World Forum for Harmonization of Vehicle Regulations

Working Party on Lighting and Light-Signalling

Proposal for a Supplement to the new UN Regulation on light-signalling devices (LSD)

Submitted by the expert from Germany*

Figure 1
Typical arrangement for the measurement of the luminance produced by the sun load impact (phantom effect).

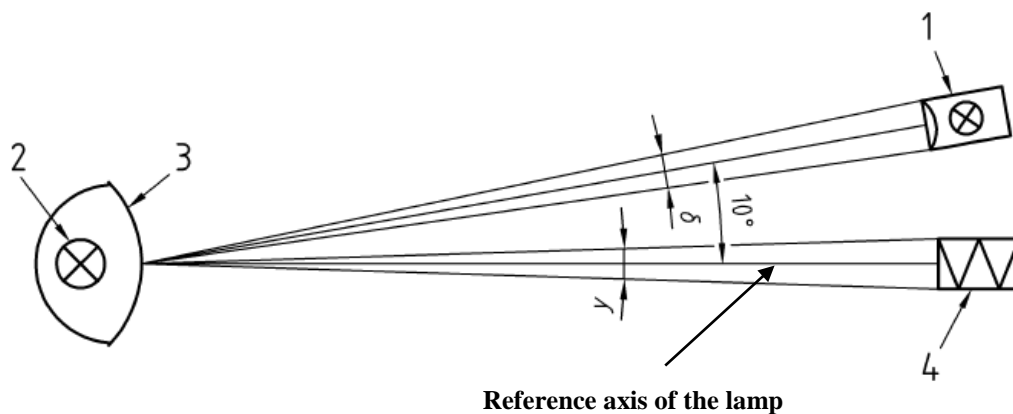
The light source generating a sun load impact according to Figure 1 below is a projector with a light source of a correlated colour temperature between 4500 K and 6500K.

The light from the projector shall illuminate at least the light emitting surface of the optical unit with the illuminance $E = 40\ 000\ \text{lx}$ and uniformity (inside the area of the light emitting surface) of 10 %.

The reference axis of the lamp and the axis of the projector shall form a vertical angle of 10° .

The plane formed from both axes shall be the operational vertical plane. The arrangement shall be in a way that the projector radiates the light as if from above the signalling lamp.

Measurements of sun load impact (phantom effect) depends strongly on the geometry of measurement. The recommended distance for measurements for obtaining comparable results is 10m.

A shorter distance is allowed as long the required uniformity of the illumination by the projector as well as all other required parameters as specified in this Annex are met and the use instruction of the measuring head allows it.

The measuring head to determine the luminance shall be placed so that the reference axis of the lamp and the axis of the measuring head coincide.
